## Service Information Letter

SIL# SL022105-001

SUBJECT: MARATHONNORCO AEROSPACE STATIC INVERTER

MODELS: PC-251-123E AND -123F

Figure 1  
Front Plate  
PC-251-123E

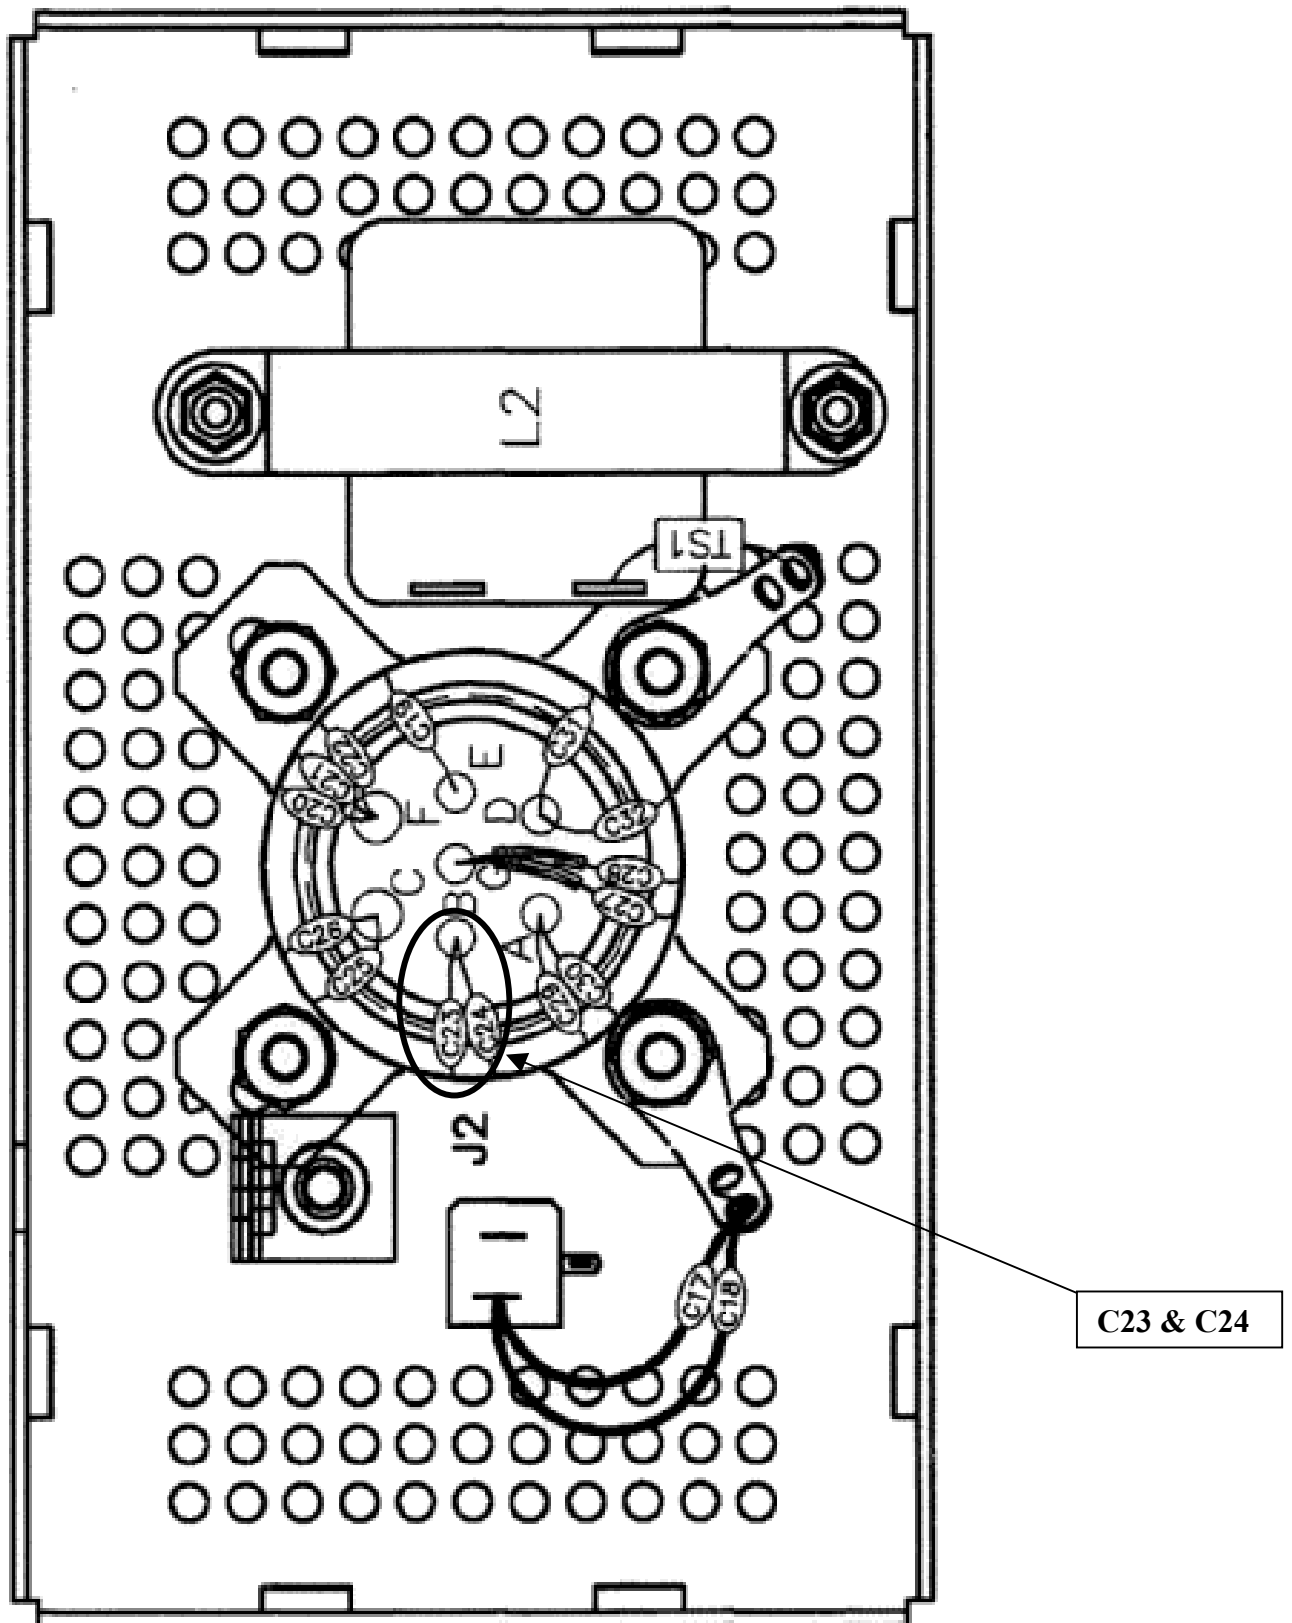
Capacitors C23 and C24 have been upgraded to 200V ceramic capacitors for HIRF qualified models PC-251-123E and PC-251-123F to improve product reliability.

- A. No immediate field action is required. When PC-251-123E and PC-251-123F inverters are removed for another reason and sent to an MNAI Authorized Repair Facility for service, capacitors C23 and C24 will be replaced with 200V parts as required on affected serial numbers.

New P/N	Description	Old P/N	Unit List Price	Special Instructions/Disposition
206-1008	Cap Rad 200V 1.0MFD	206-1007	6.30	*Return to Marathon
206-1009	Cap Rad 200V 0.01MFD	206-1004	0.38	*Return to Marathon
